Homework #20

Response to questions regarding Water Management Plan Figures 6-3 and 6-6.

Revised Figure 6-3 (above)

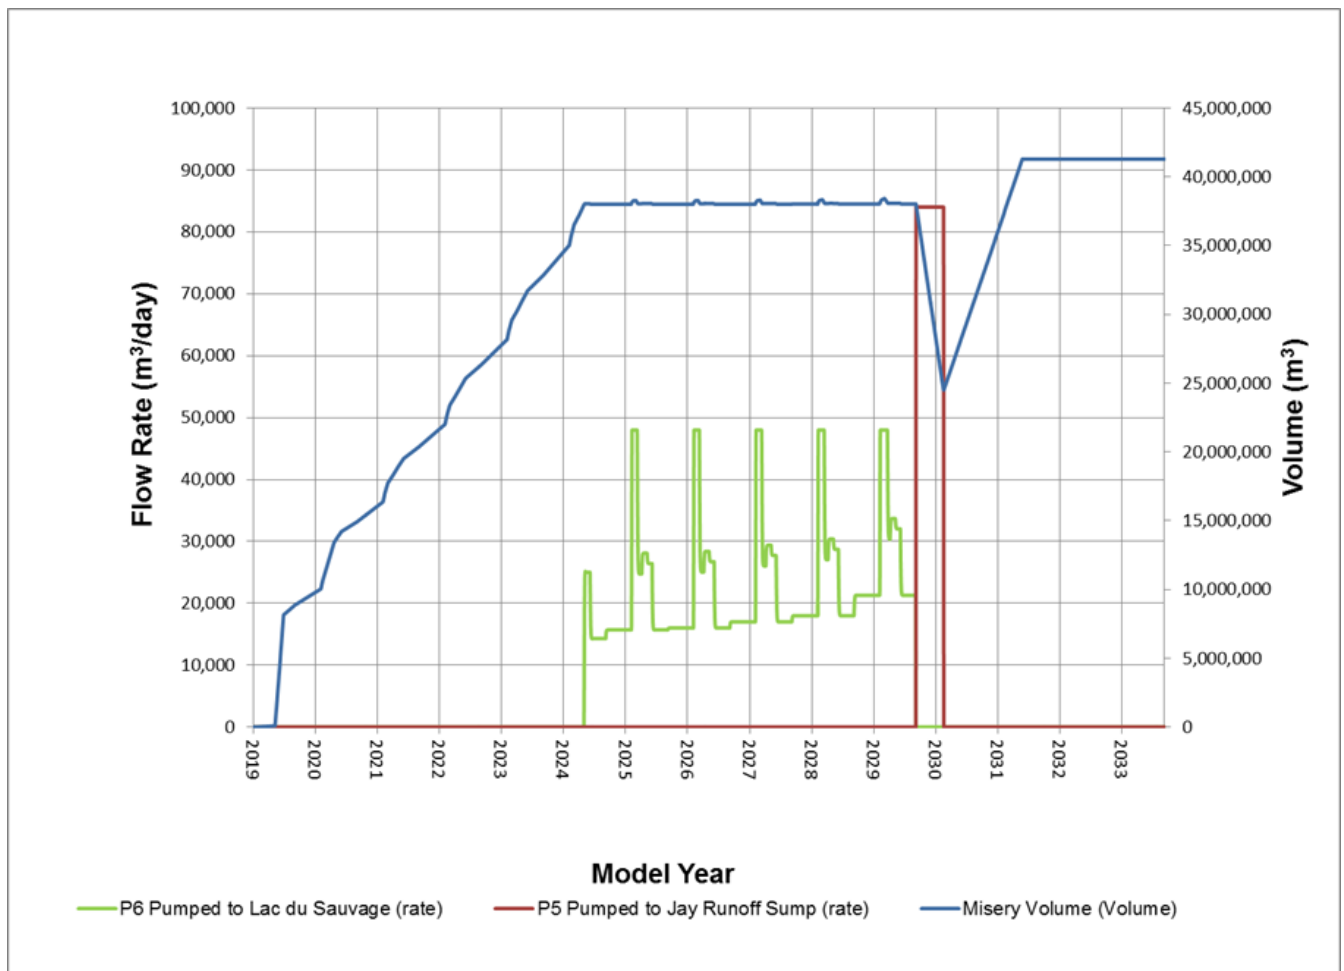
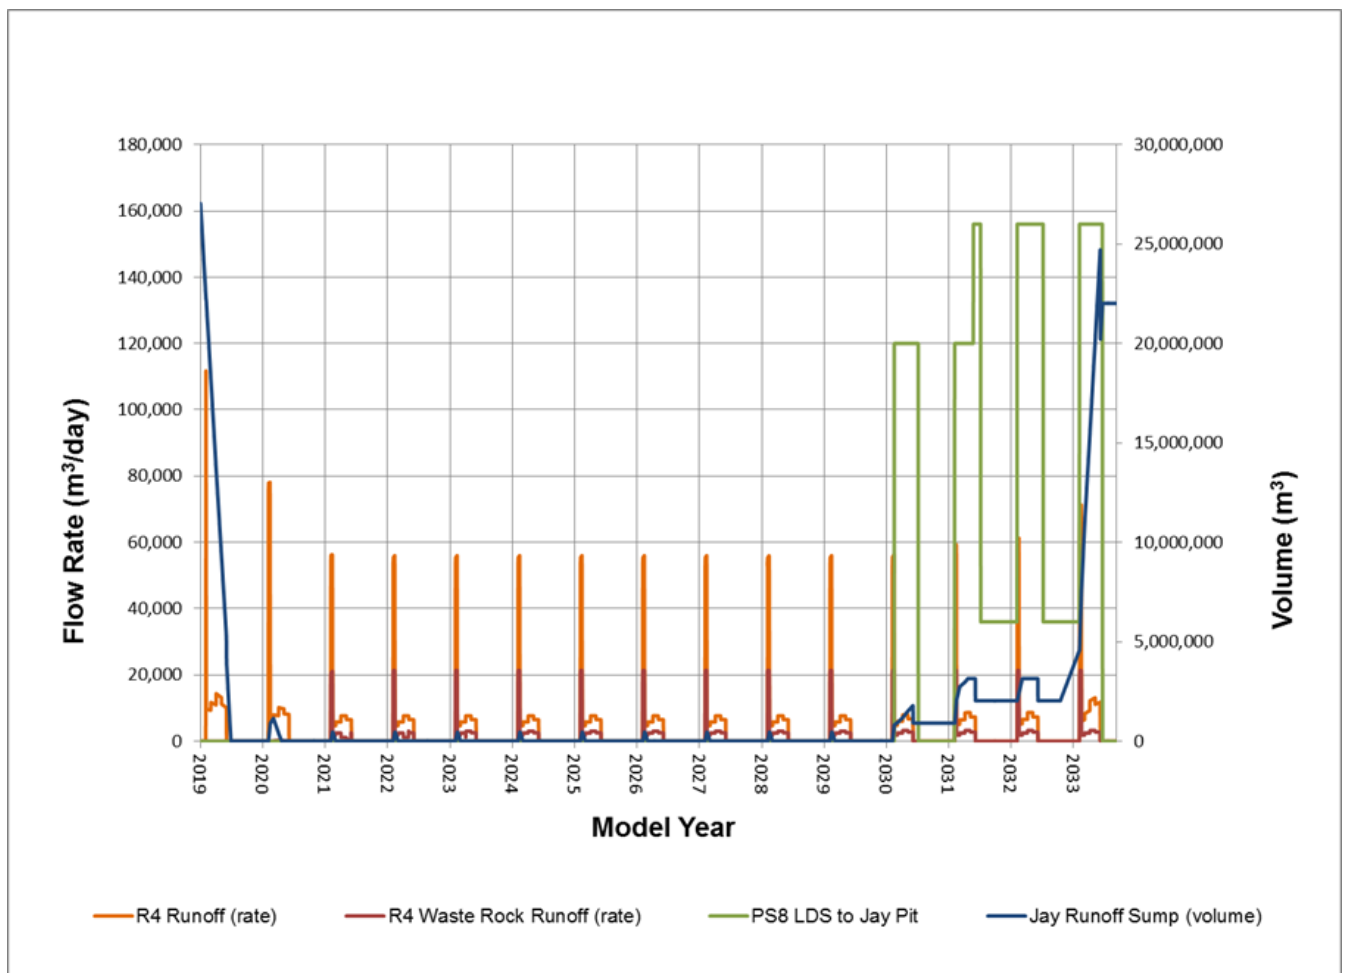
Figure 6-3: There appears to be a discrepancy in the figure, as the duration of the drawdown of Misery Pit in 2029 and 2030 [series “Misery Volume (Volume)"] does not correspond to the duration of the pumping to Jay Sump [series “P5 Pumped to Jay Runoff Sump (rate)"].

Response: Misery Pit was modeled in layers, and this figure only shows the pumping from the first layer of three. The corrected figure is shown below. *The water balance considered pumping from all three layers; the only error is in the figure.*
